**Safety recommendation: AIC 19-R02/18-1004**

**Addressed to: Honeywell Aerospace**

**Investigation link: AIC 18-1004**

Figure 2: Derived Data plotted against Honeywell EGPWS MK V Mode 1 Graph

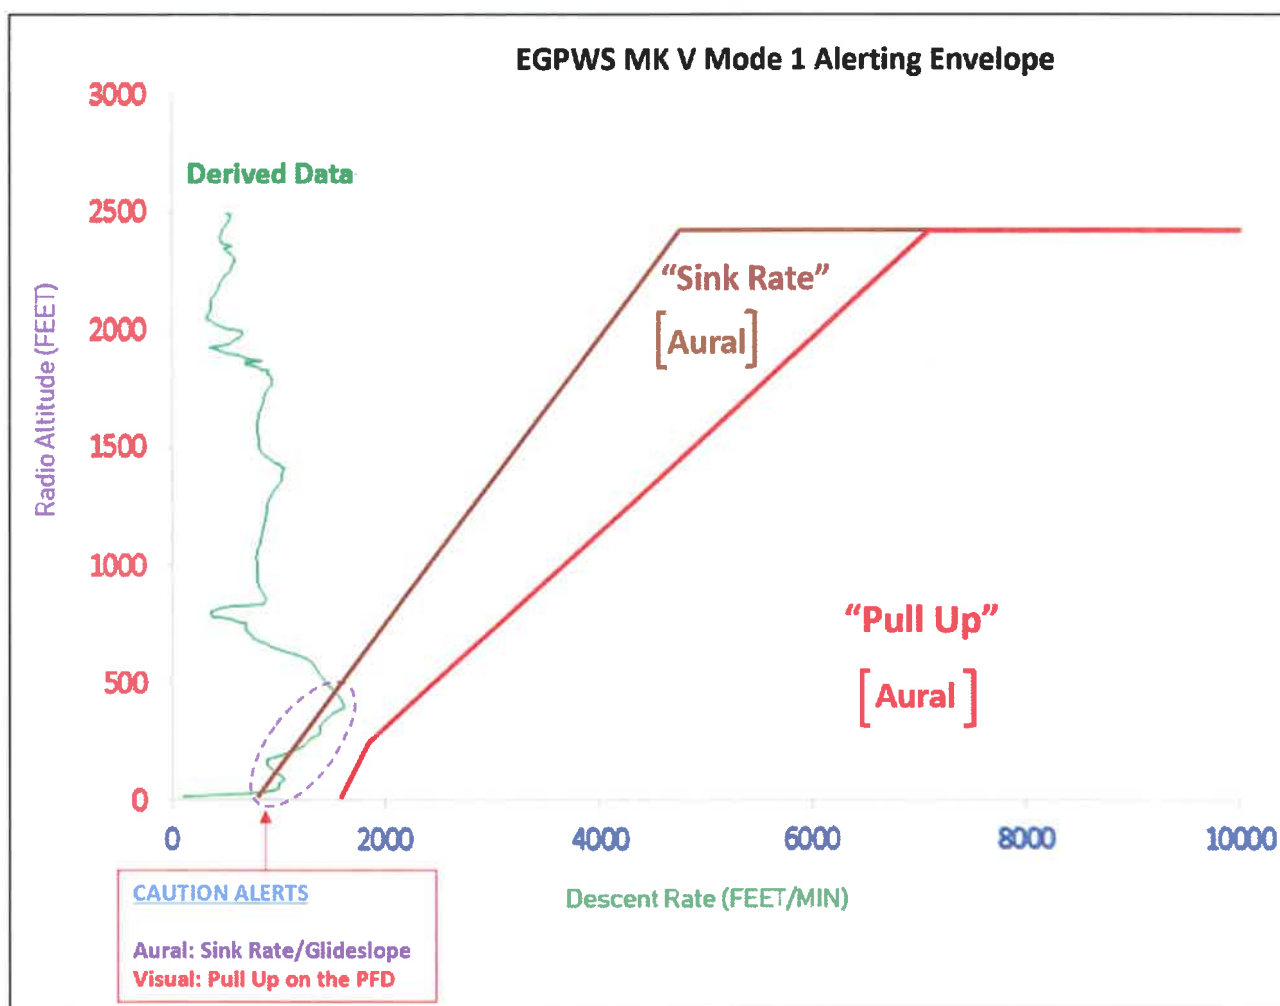
The investigation into this accident has found that the crew did not take any remedial action in response to the *Glideslope* and *Sink rate* Caution Alerts (aural alerts). The EGPWS issued these Caution Alerts (aural alerts) that included the words **PULL UP** appearing steady in red on the Primary Flight Display (*Electronic Flight Instrument System*) when the aircraft penetrated the Sink Rate Envelope of the Honeywell EGPWS MK V Mode 1 Graph. See Figure 2.

The investigation has determined that a continuous “WHOOP WHOOP PULL UP” hard aural warning, simultaneously with the steady visual display of **PULL UP** on the Primary Flight Display, should replace the *Sink rate* Caution Alerts (aural alerts) when the aircraft continues to descend below 500 ft Radio Altitude and below the glideslope, to alert a crew of the imminent danger.

The PNG Accident Investigation Commission recommends that Honeywell Aerospace should ensure that the Honeywell EGPWS MK V Computer provides timely and continuous hard aural warning "*WHOOP WHOOP PULL UP*," simultaneously with the stable visual display of **PULL UP** on the Primary Flight Display, which requires immediate action from the crew, when encountering an excessive Rate of Descent at very low Radio Altitude, similar to that encountered by the crew of P2-PXE as shown in Figure 1.

1. *Boeing and/or operator has chosen to drive a red “**PULL UP**” annunciation on the PFD when the EGPWS triggers a Mode 1 “Sink Rate” caution alert level when another option is available which would not generate the red “**PULL UP**” annunciation with the same caution level alert; and*
2. *If Honeywell were to change the EGPWS Mode 1 Warning curves to generate a “**PULL UP**” aural when a flight profile were to be flown as P2-PXE performed, it would be in violation of TSO-151d (MOPS DO-367) and would be unable to certify the product with the FAA.*

Given the points of this response, Honeywell Aerospace requested that the recommendation be removed from consideration and stated that it would not be feasible nor within Honeywell’s control to accomplish.

**Figure 3: Mode 1 Sink Rate Alert Curves with DO-367 "Must Not Alert (Warning)" Requirement<sup>11</sup>**

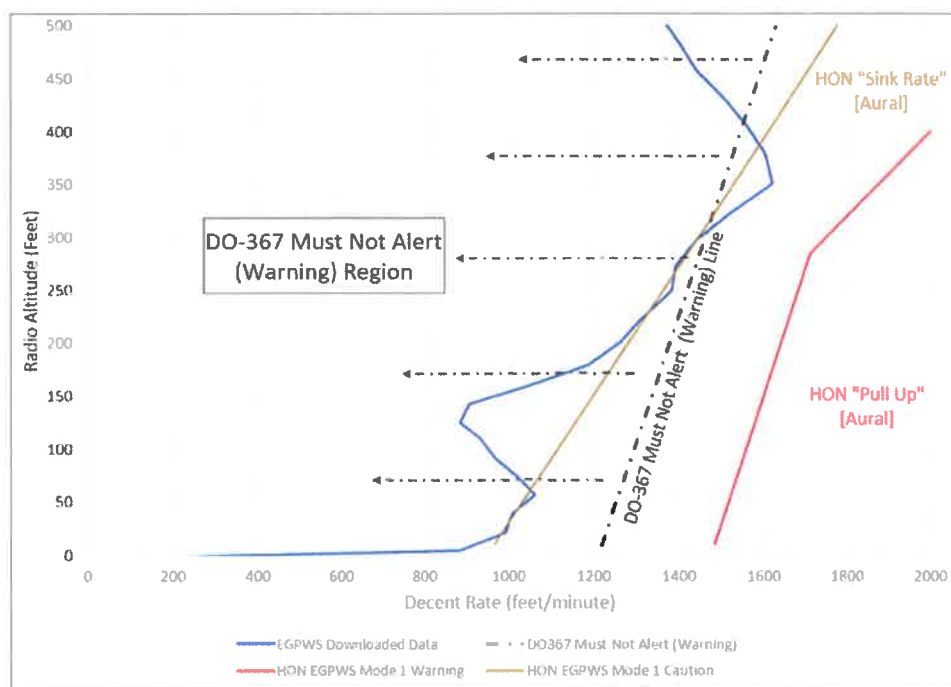
Figure 3 depicts the **HON "Pull Up" [Aural]** boundary of the HON EGPWS Mk V Mode 1 Warning. It shows:

At 275 feet Radio Altitude and 1,750 feet/min rate of descent the time to impact would be 9.4 seconds.

At 200 feet Radio Altitude and 1,650 feet/min rate of descent the time to impact would be 7.2 seconds.

At 100 feet Radio Altitude and 1,750 feet/min rate of descent the time to impact would be 9.4 seconds.

At 50 feet Radio Altitude and 1,500 feet/min rate of descent the time to impact would be 2.0 seconds.

As per *DO-367 'Must Not Alert (Warning)' requirement* region (as depicted in Figure 2), with the engine spool-up time and the time it will take to compensate for the loss of altitude for a positive rate of climb, there is insufficient time for pilots to react to an immediate time-critical situation if there is no 'WARNING' alert issued at low altitude after entering the *DO-367 'May Alert' and 'Must Alert' regions*. The rate of descent during the approach into Chuuk as shown in Figure 1, clearly shows that the crew were outside the safety margin.

The PNG Accident Investigation Commission recommends that Honeywell Aerospace, in consultation with the Federal Aviation Administration, should re-evaluate *TSO's 151b and 151d* and *DO-367* related to EGPWS warnings and cautions, and ensure that the Honeywell EGPWS MK V Computer provides a **timely warning** in the form of a continuous **flashing** visual display of '**PULL UP**' at the bottom of the Primary Flight Displays, as an absolute minimum standard. The **flashing** visual display '**PULL UP**' warning, simultaneously with the aural caution 'SINK RATE', would require immediate action from the flight crew when encountering an excessive Rate of Descent at very low Radio Altitude, similar to that flown by the crew of P2-PXE as shown in Figure 1.
